MALLORY Mallory Sonalert Products, Inc. Part #: **Sales Outline Drawing**

SC628AF Revision:

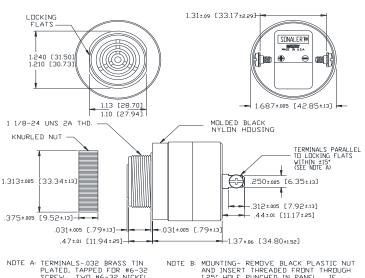
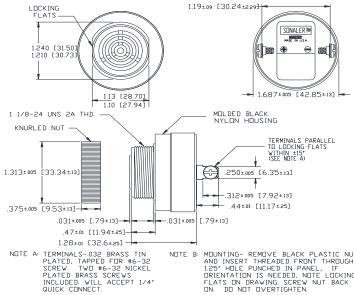
PART DIMENSIONS BEFORE CODE DATE: 1145 5

PART DIMENSIONS AFTER CODE DATE: 1146 1
